<b>Subject:</b>  <b>FRONT / REAR STABILIZER NOISE PREVENTION</b>	<b>Bulletin No:</b> 02-005/16
	<b>Last Issued:</b> 02/17/2016

## BULLETIN NOTE

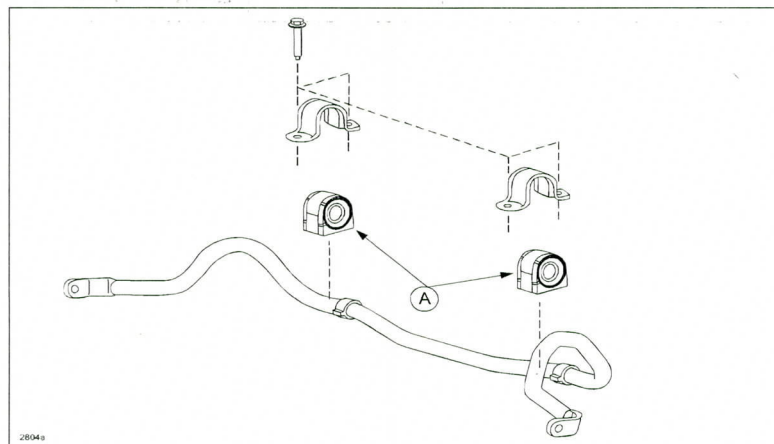
Beginning with the newer models (CX-5 and Mazda6), grip type front and rear stabilizer bushings (A) have been incorporated for noise prevention purposes. If any type of grease or lubrication is applied to the bushings, it may create noise due to bushing slippage (CX-5 front bushings shown below).

**NOTE:** To prevent noise from occurring, never apply any type of grease or lubrication to the front or rear stabilizer bushings.
